[S802.16d-03/05]

[Changing the method to transmit STC preamble and inserting STC preamble in OFDM system with 2 transmit antennas]

STC (Space-Time Code)

Preamble Sequence in OFDM system

STC Preamble Transmission Method

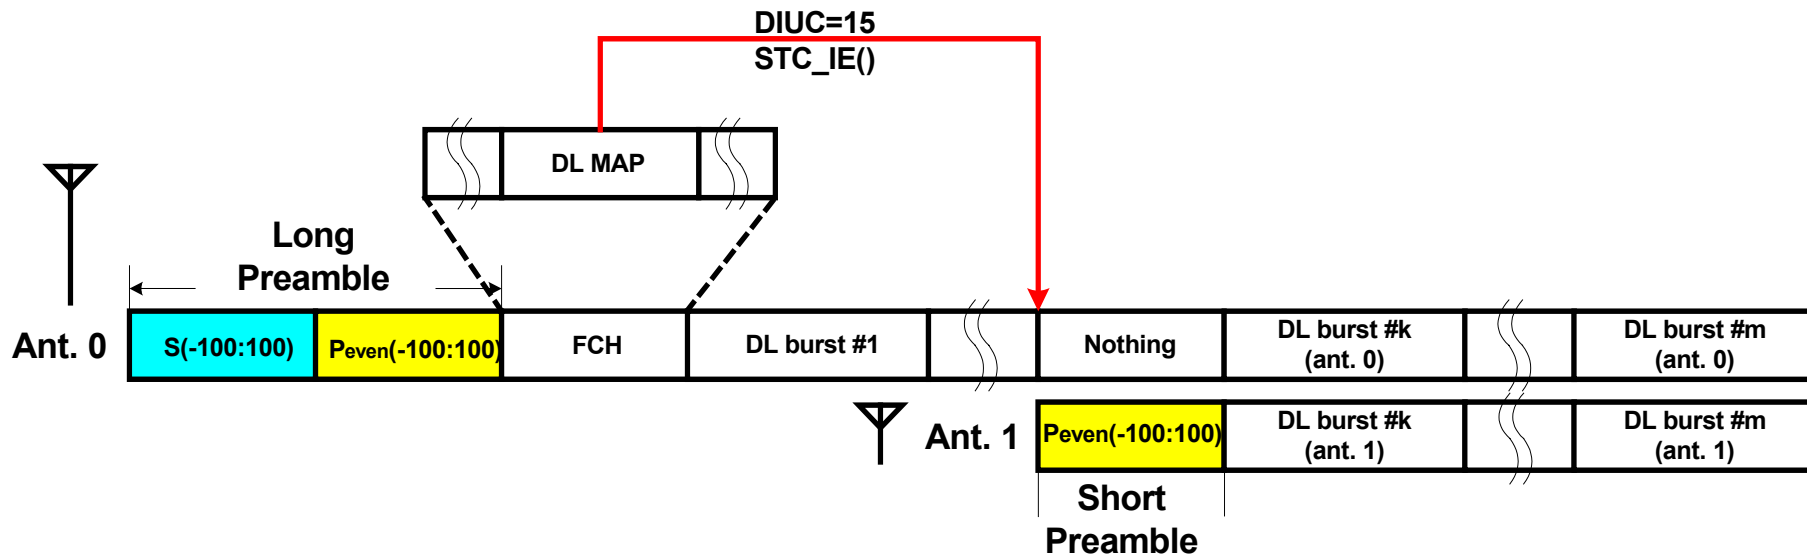
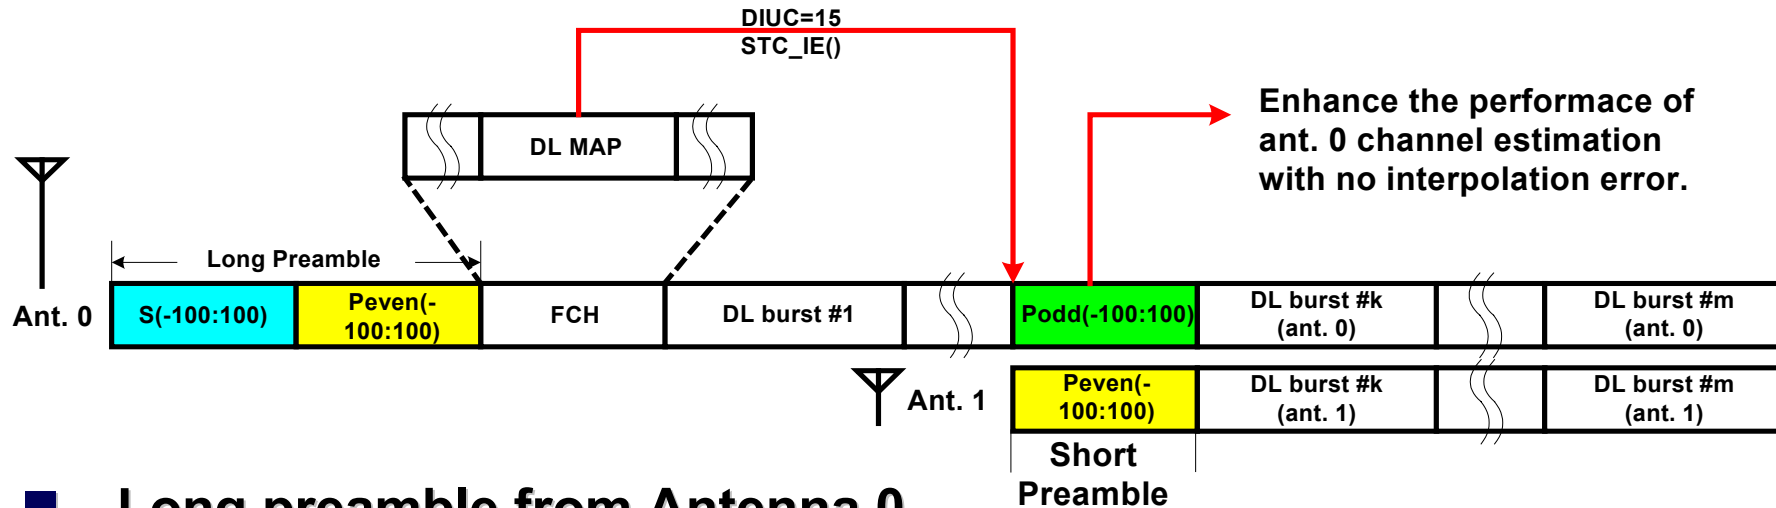
- Long preamble from Antenna 0
 - ◆ Synchronization
 - ◆ Channel Estimation
- Short preamble from Antenna 1
 - ◆ Transmission during $\text{DIUC}=15 \text{ STC_IE}()$
 - ◆ $P_{\text{even}}(-100:100)$

- Long preamble from Antenna 0
 - ◆ Synchronization
 - ◆ Channel Estimation
- Short preamble from **Both** Antenna 0 and Antenna 1
 - ◆ Transmission during DIUC=15 STC_IE()
 - ◆ $P_{odd}(-100:100)$ from Antenna 0
 - ◆ $P_{even}(-100:100)$ from Antenna 1

STC Short Preamble Sequence Using Odd Carriers

$$P_{\text{odd}}(-100:100) = \{0, -1, 0, -1, 0, +1, 0, -1, 0, +1, 0, -1, 0, +1, 0, +1, 0, -1, 0, -1, \\ 0, +1, 0, +1, 0, -1, 0, +1, 0, -1, 0, +1, 0, -1, 0, -1, 0, +1, 0, +1, \\ 0, +1, 0, +1, 0, -1, 0, +1, 0, -1, 0, +1, 0, -1, 0, -1, 0, +1, 0, +1, \\ 0, -1, 0, -1, 0, +1, 0, -1, 0, +1, 0, -1, 0, +1, 0, +1, 0, -1, 0, -1, \\ 0, -1, 0, -1, 0, +1, 0, +1, 0, +1, 0, +1, 0, +1, 0, -1, 0, +1, 0, +1, \\ 0, -1, \\ 0, -1, \\ 0, -1, 0, +1, 0, -1, 0, +1, 0, +1, 0, -1, 0, -1, 0, -1, \\ 0, -1, 0, +1, 0, +1, 0, +1, 0, +1, 0, +1, 0, +1, 0, -1, 0, +1, 0, +1, 0, -1, \\ 0, -1, 0, +1, 0, +1, 0, +1, 0, +1, 0, +1, 0, +1, 0, -1, 0, +1, 0, +1, 0, +1, \\ 0, +1, 0, -1, 0, -1, 0, -1, 0, -1, 0, -1, 0, -1, 0, +1, 0, -1, 0, -1, 0\} \\ * \text{sqrt}(2) * \text{sqrt}(2)$$
